STAGE/STATUS  
DA SUBMISSION  
DRAWING TITLE  
BREWHOUSE CARWASH LAYOUT  
DRAWING NO. ISSUE DATE DRAWN  
A2.101 B 05 MAR 20 BHG

Re: DA 2021/0004  
Car Wash  
160 North Street, Grafton NSW 2460  
Lot 13 DP 1120659  
DCS Building & Consulting

**SECTION 4.15 EVALUATION FOR DA2021/0004**  
**- Lot 13 DP 1120659- 160 North Street GRAFTON NSW 2460**

**Additional Information Requested – DA2021/0004 – Reply.**

BREWHOUSE CARWASH - EAST & WEST ELEVATION

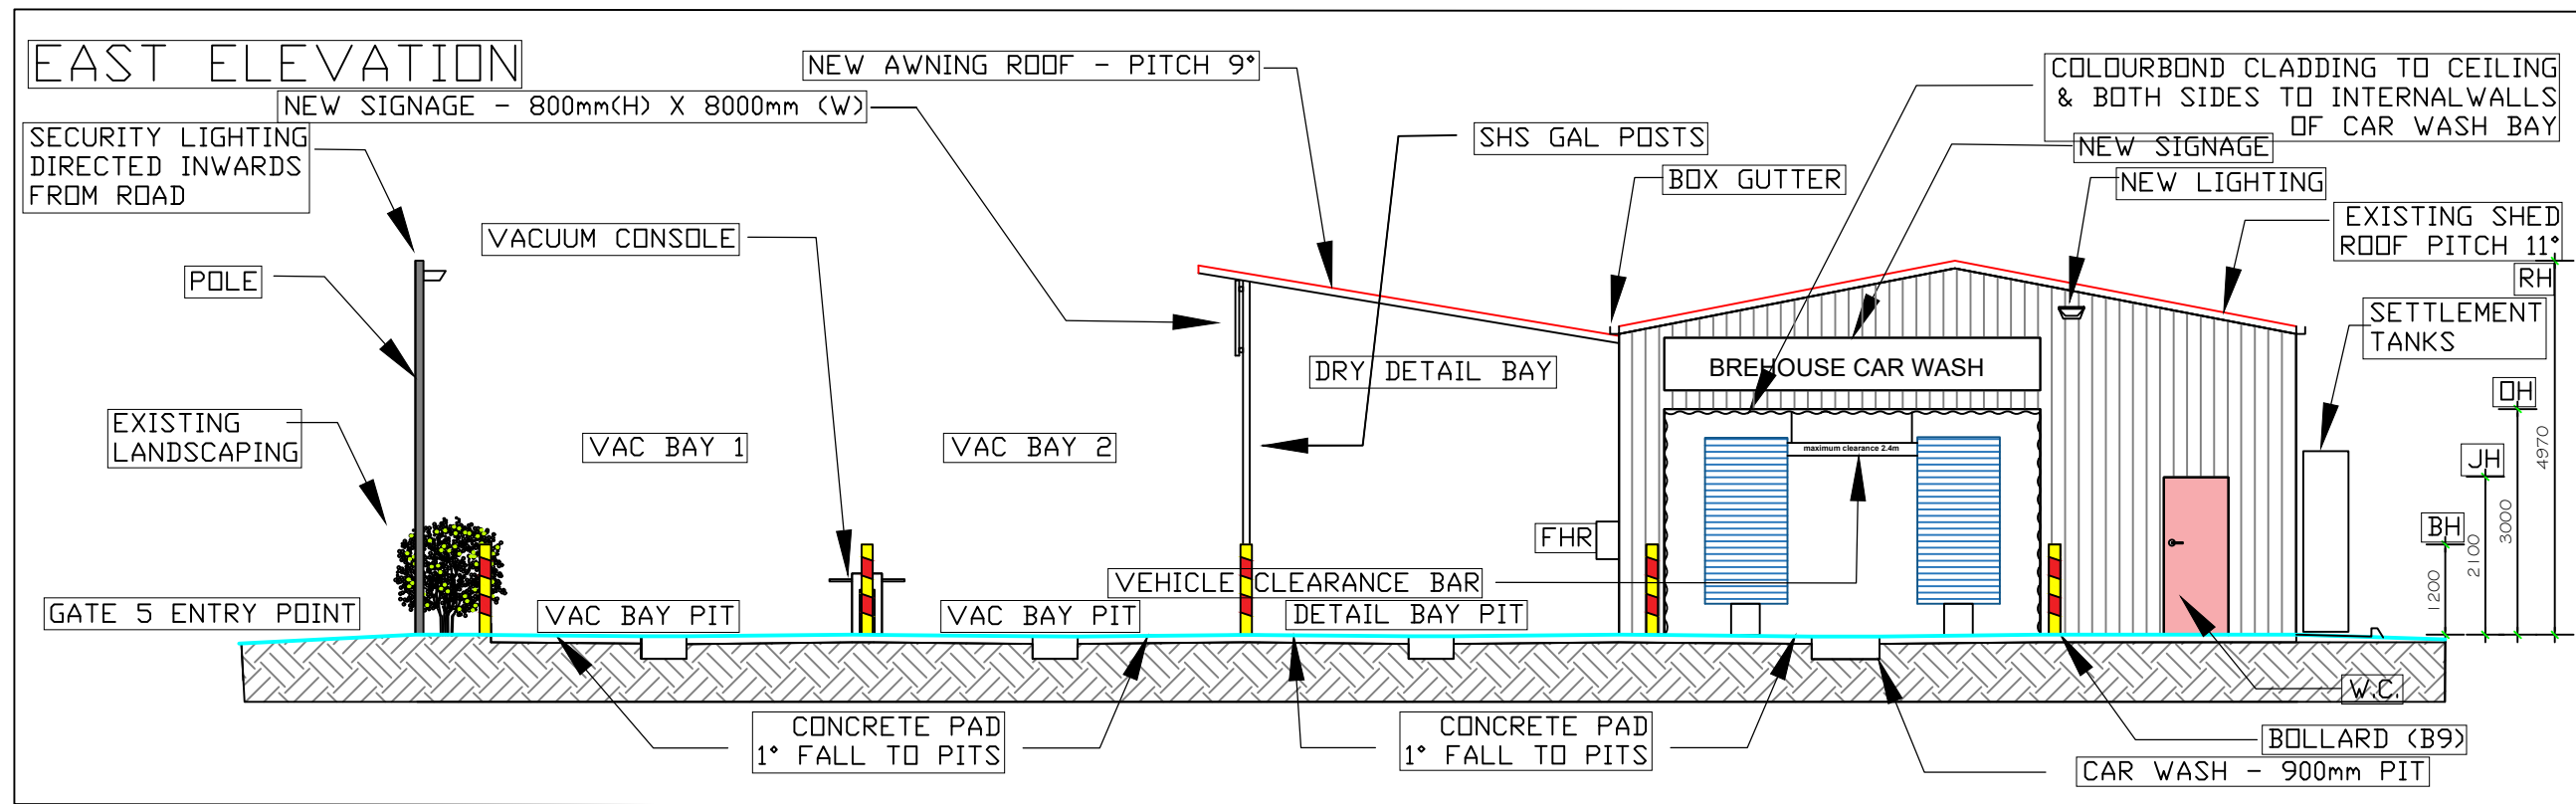
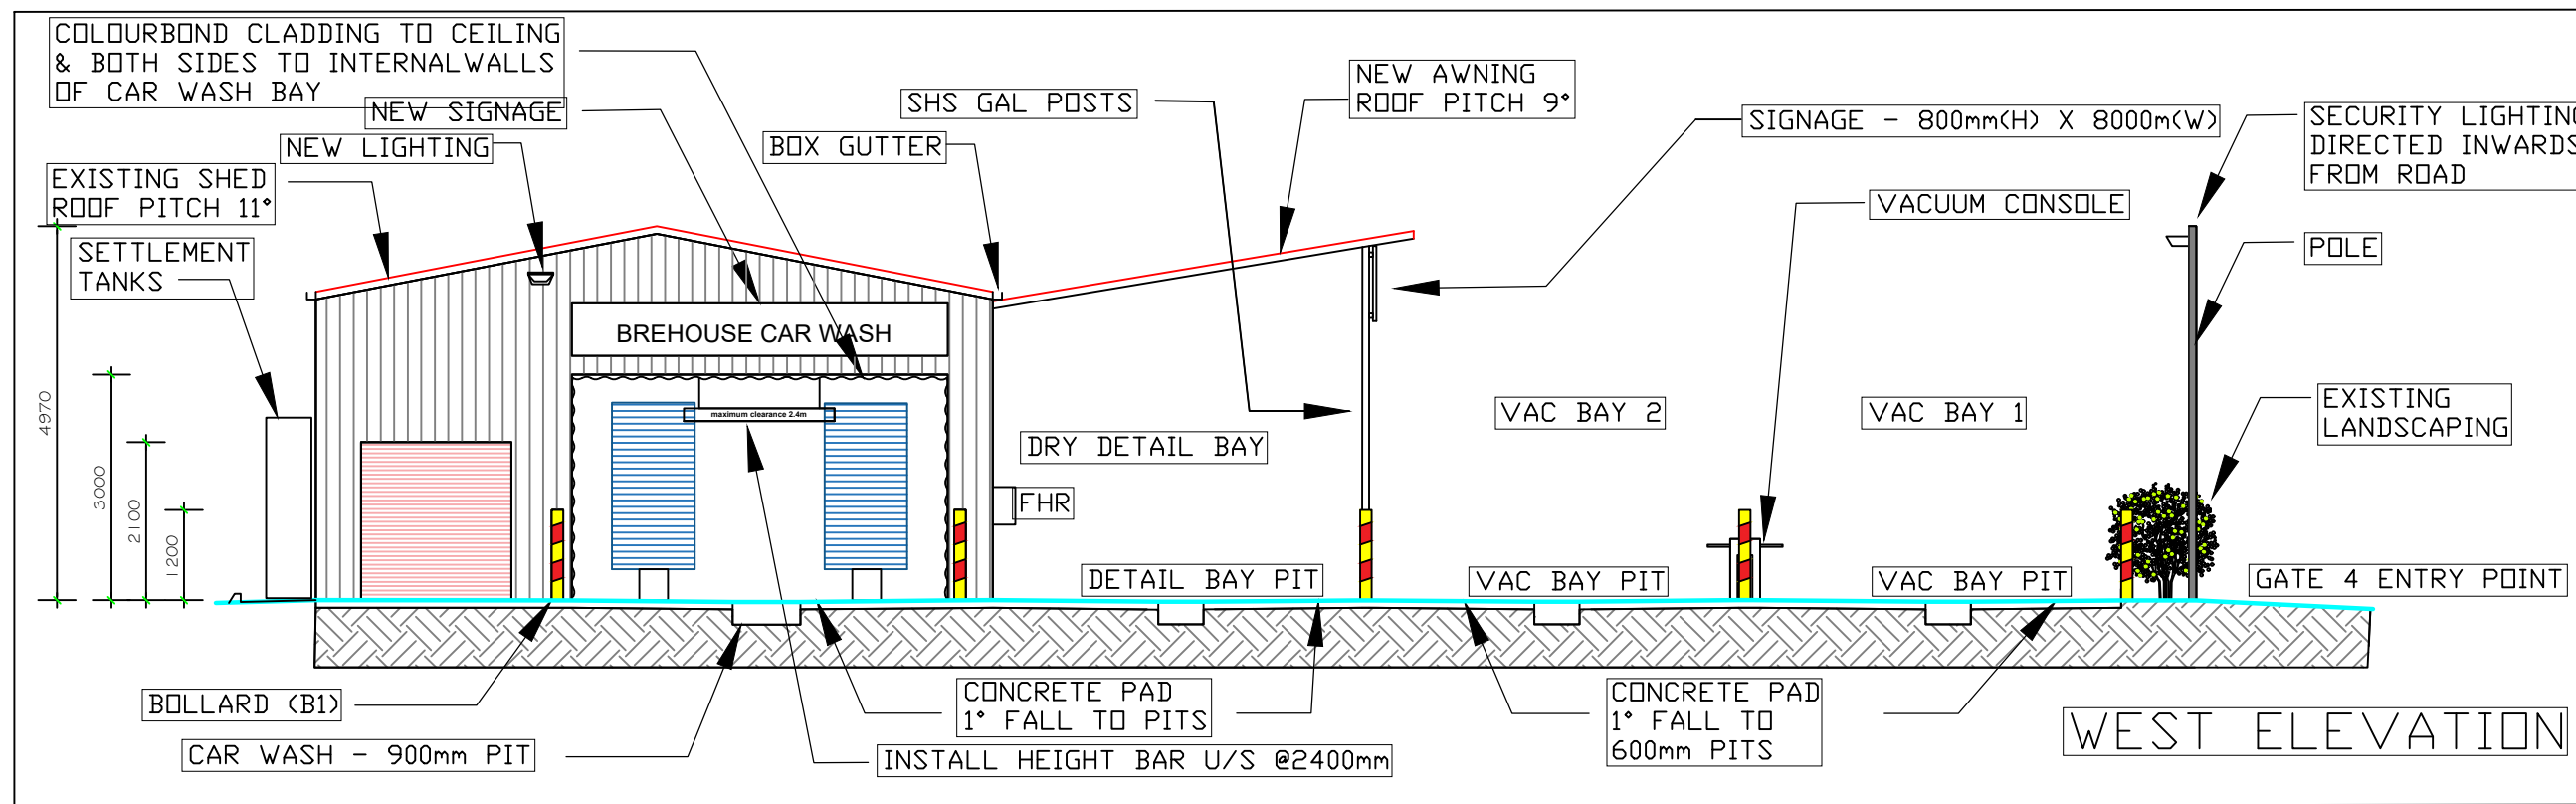
A height restricting bars will also be present as highlighted on DCS drawings A3 101 on the western elevation. This will determine that B85 and B99 vehicles will be able to enter and exit the Carwash. No trucks will be able to use this service.

c.	<p>Open sides of the sheds are to have a roof/eave that overhangs the edge of the bunded area by a minimum 100 from the vertical to minimise rain-water ingress.</p>	<p>The owner has taken action to amend the drawings to reflect this oversight.</p> <p>The roof overhangs will reflect an awning protruding from the wall.</p> <p>Refer DCS drawing A3 101 &amp; A3 102 dated 22<sup>nd</sup> February 2021.</p>

STAGE/STATUS  
 DA SUBMISSION  
 DRAWING TITLE  
 ROOF STORM WATER & SEWER DRAINAGE PLAN  
 DRAWING NO. ISSUE DATE DRAWN  
 A4.101 B 05 MAR 21 BHG

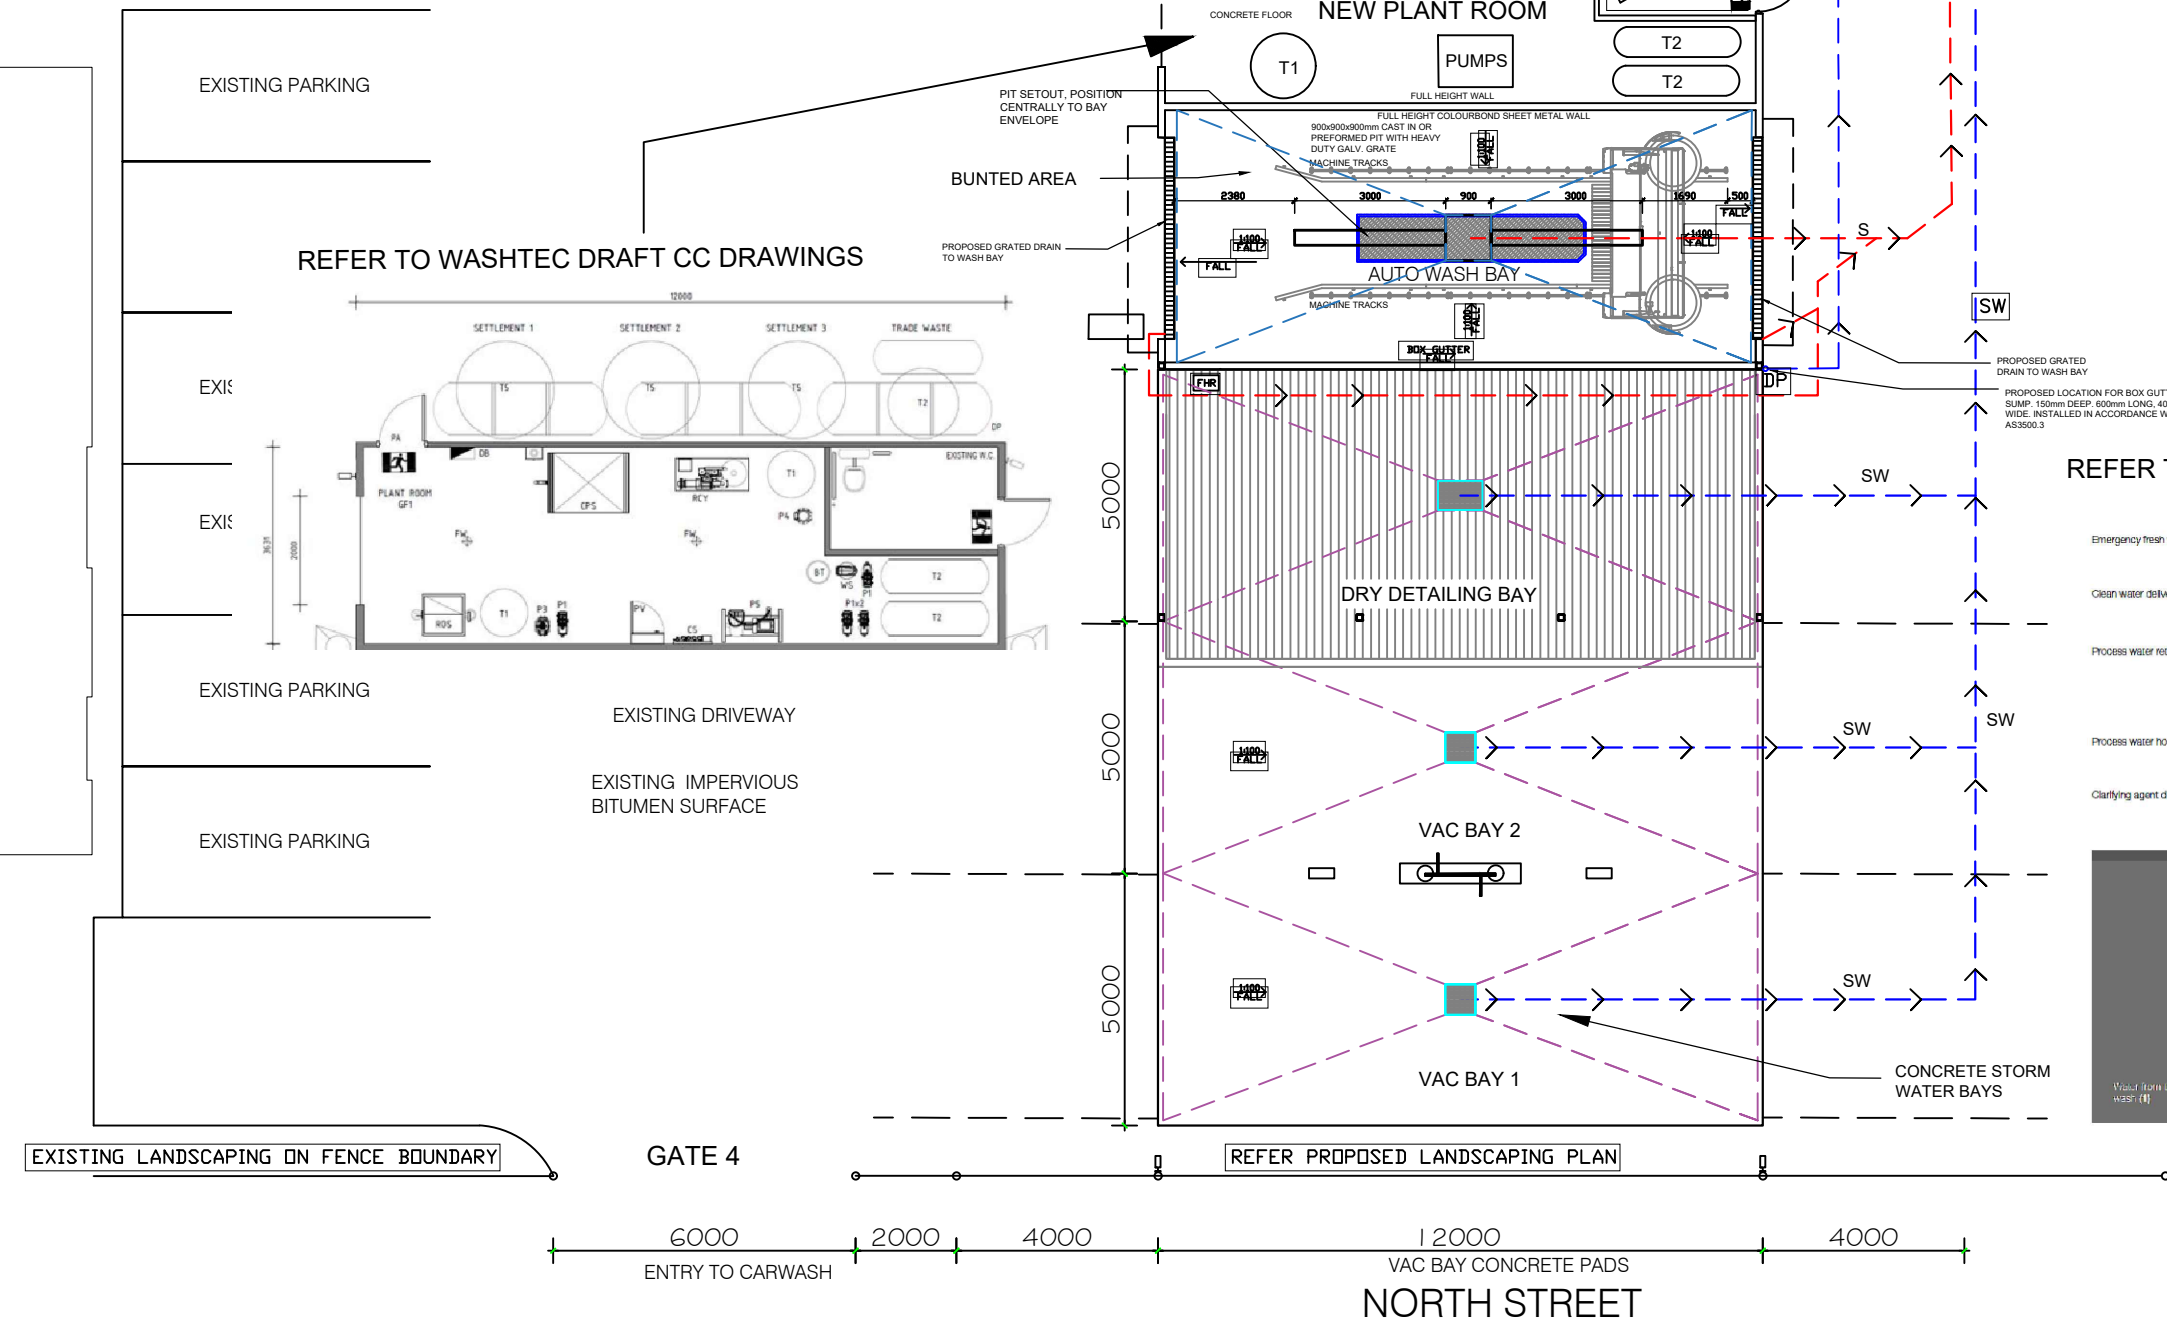
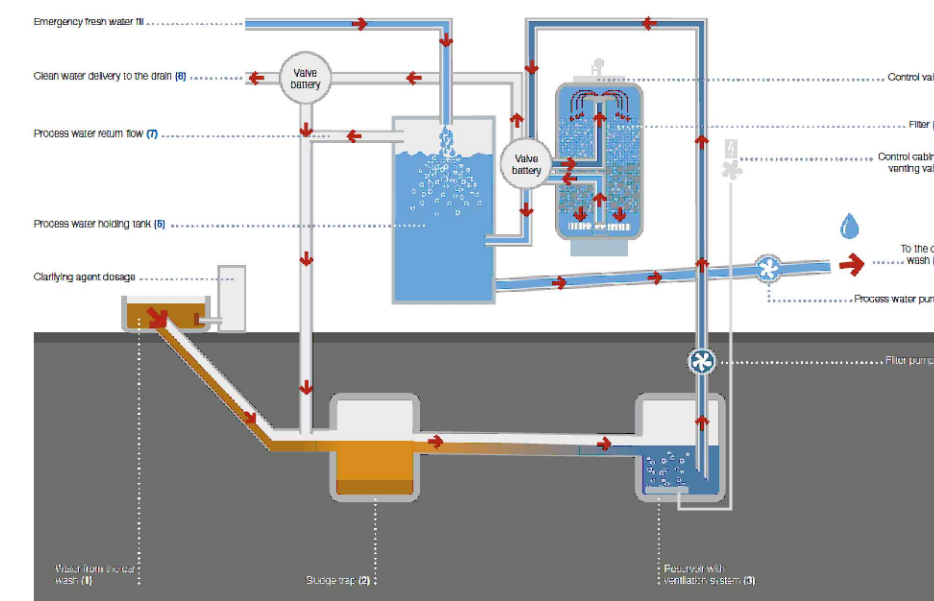
Item	Requested Information	Reply Comments
a.	Show the location of the oil separator.	<p>The Oil separator is located within the plant room.</p> <p>DCS drawing A4 101 has been amended to reflect this event as well as Soft-care Pro Touchless Technical Sheet.</p>

b.	<p>The settlement tanks and sewer discharge tank included in the Washtec water recycling system and oil separator are required to be installed in a roofed and bunded area. The bunded capacity is to be at least 110% of the volume of the largest tank.</p>	<p>The settlement tanks are located on the northern side of the Car Wash shed. Which can not be seen from the street, therefore, considered low impact on the immediate area from a visual aspect.</p> <p>The owner will bunt the area and take into consideration the volume of the largest tank. But does not understand why the area needs to be roofed as all storm water collected within the bunded area will flow to the retention basin that is existing on site.</p> <p>The storm water impervious water in this area is existing and will not change given that the settlement tanks will be located at the rear of the shed.</p>

d.	<p>Stormwater is not permitted to be discharged to the sewer system.</p> <p>Connection of the downpipes to the settlement tanks forming part of the trade waste pre-treatment system is not permitted.</p> <p>If rainwater is proposed to be harvested for use in the wash bay a separate dedicated rainwater tank will be required.</p>	<p>DCS Drawing has been amended to reflect this oversight of storm water being directed towards the settlement tanks and sewer system.</p> <p>All storm water from impervious surfaces will be directed to the existing retention basin on site.</p> <p>The decision to harvest the rainwater is still been considered. But given the nature of the Washtec technology with recycling in mind, the owner will be reluctant to move forward with this intention. Unless this is stipulated as part of the reduction of fees and charges to alleviate any concerns of fresh water being used excessively. Which is considered to be the main concern of the owner given his original/previous initiative.</p>

STAGE/STATUS  
 DA SUBMISSION  
 DRAWING TITLE  
 WASH BAY TRENCH  
 DRAWING NO. ISSUE DATE DRAWN  
 A5.101 A 05 MAR 20 BHG

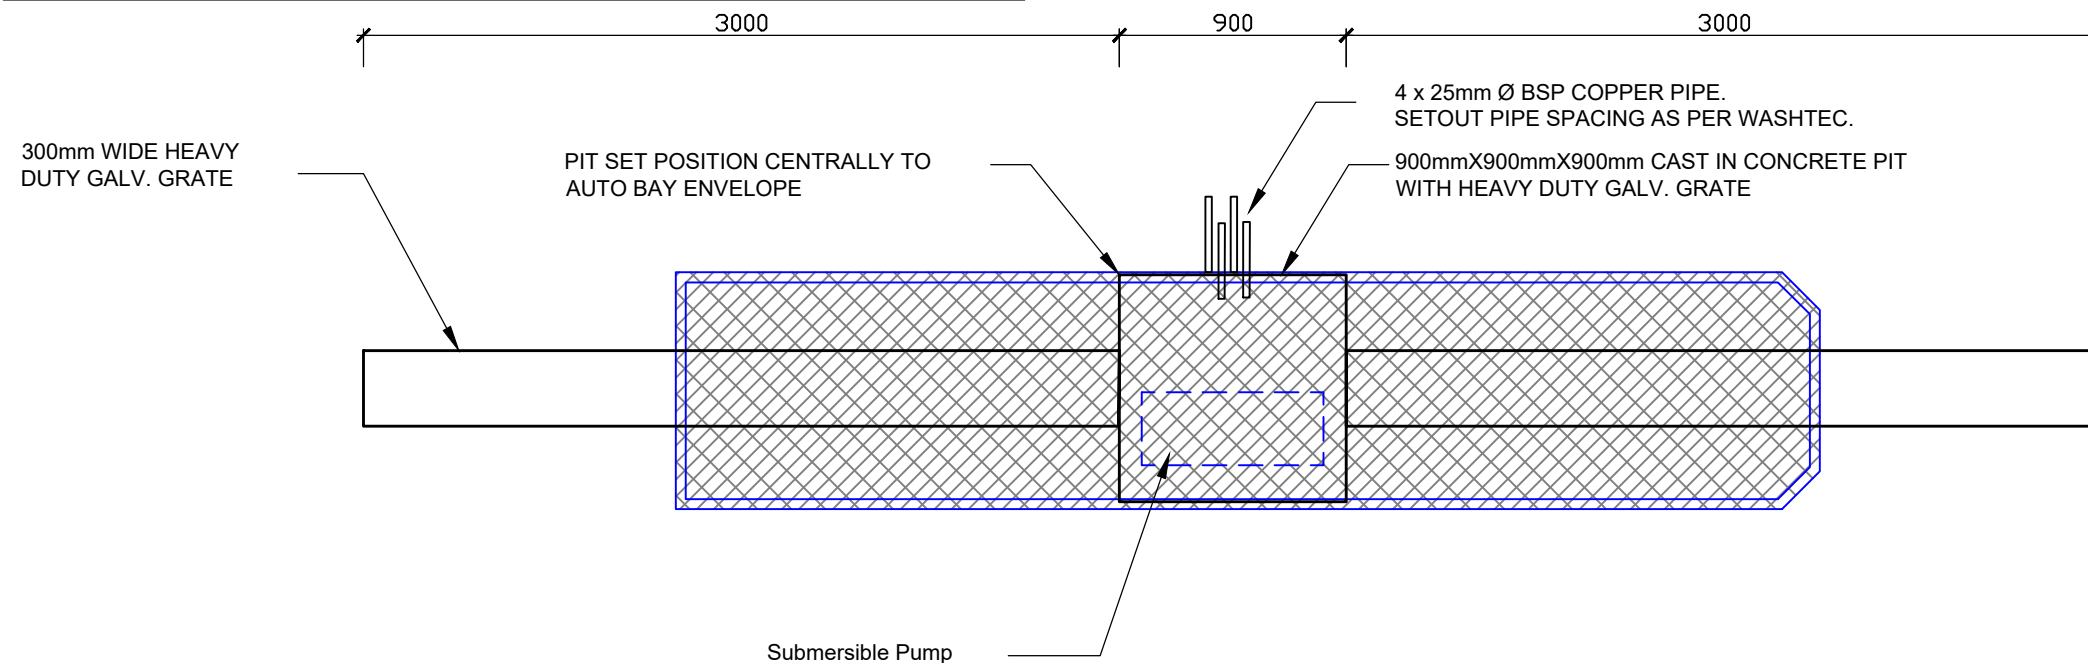
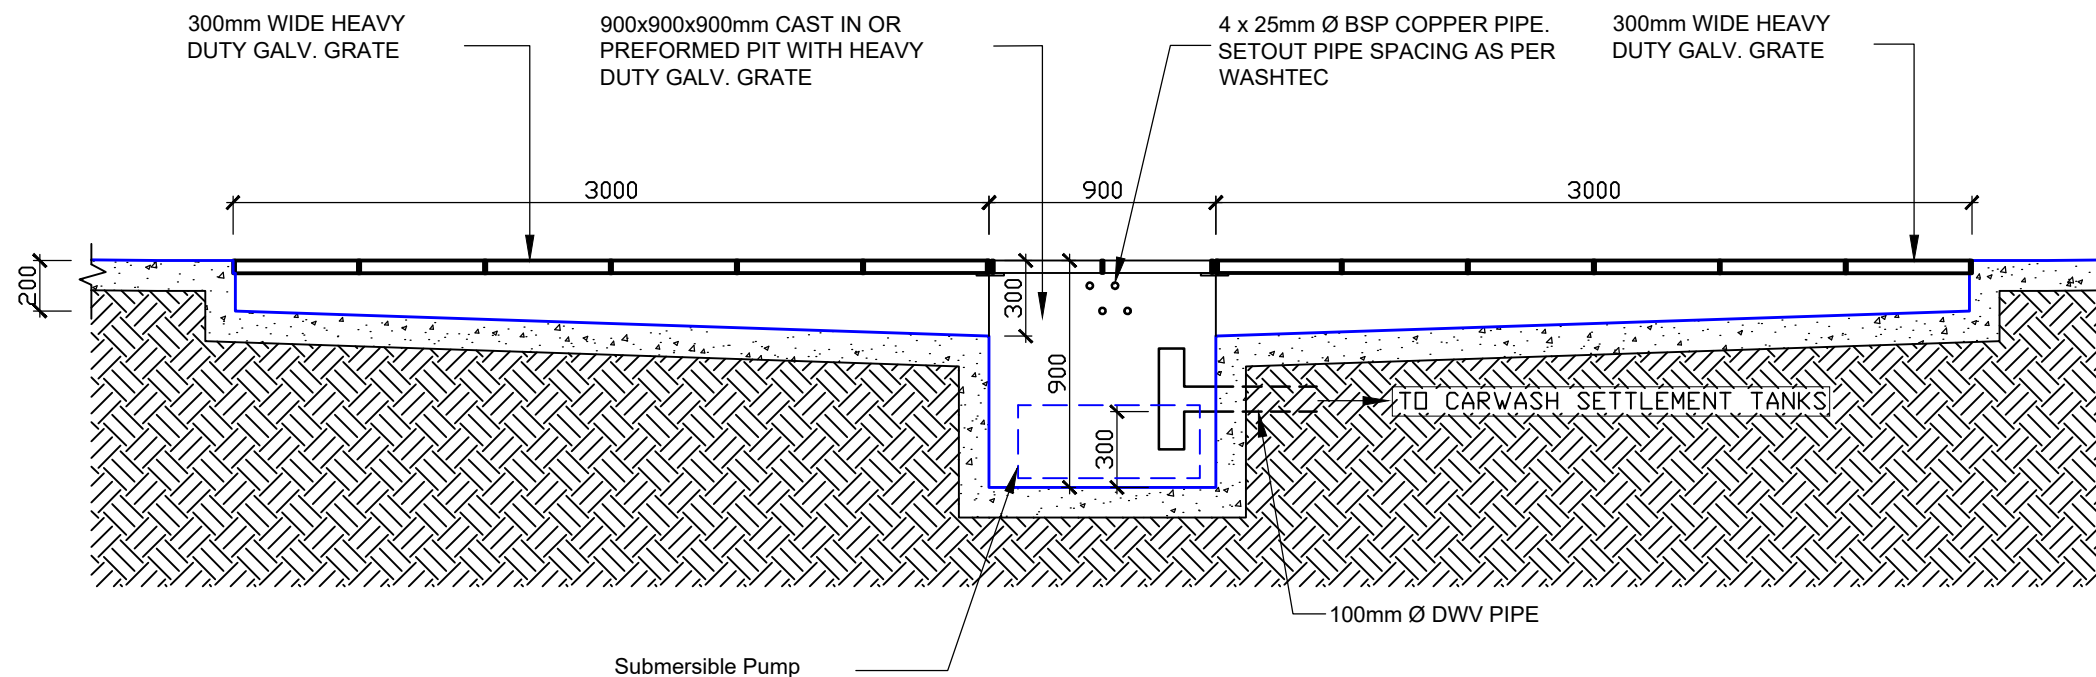
<p>impervious storm water from the existing hardstand surfaces.</p> <p>Amended DCS drawings reflect this anomaly.</p>
f.	<p>The Wash Bay trench elevations show approximately 0.24m<sup>3</sup> (900mm x 900mm x 300mm) of storage at the invert of the pipe to the settlement tank.</p> <p>The intended function of this area below the invert is to be nominated and how this area will be managed.</p>	<p>The Wash Bay pit will incorporate a submersible pump which conveys the pre-cleaned water from the storage tank to the filter system and pushes it through the filter from top to bottom.</p> <p>Existing suspended particles are filtered off and the cleaned water is stored in the water reclaim storage tank. It is thus available again as washing water. (95% - 100%)</p> <p>Further information can be gained from the attached Washtec's technical advice for architects and government authority's brochure.</p>
